Amendment Notice 2

Licence Number L8739/2013/1

Premises Wonnerup Mineral Sands Mine

Date of Amendment Friday, 2 November 2018

Map of noise bund locations

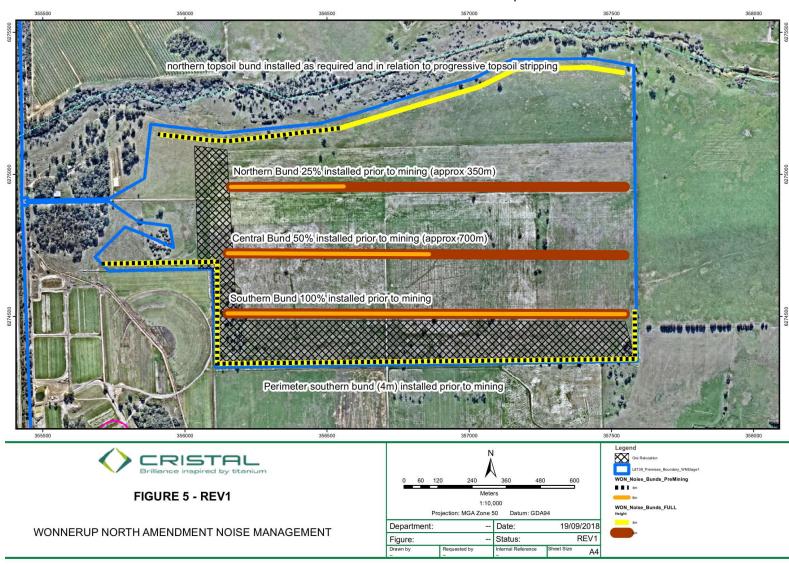
Must construct: • A 6 m high ore noise bund at least 700 m long and approximately 400 m north of the southern boundary of M70/360; and	'Central bund) on map in Schedule 1

Prior to commencing Mining Operations relating to the Wonnerup North site (M70/360) 	
 Must construct: A 6 m high ore noise bund at least 350 m long 	'Northern bund' on map
and approximately 600 m north of the southern boundary of M70/360; and	in Schedule 1
 Prior to commencing Mining Operations relating to the Wonnerup North site (M70/360)
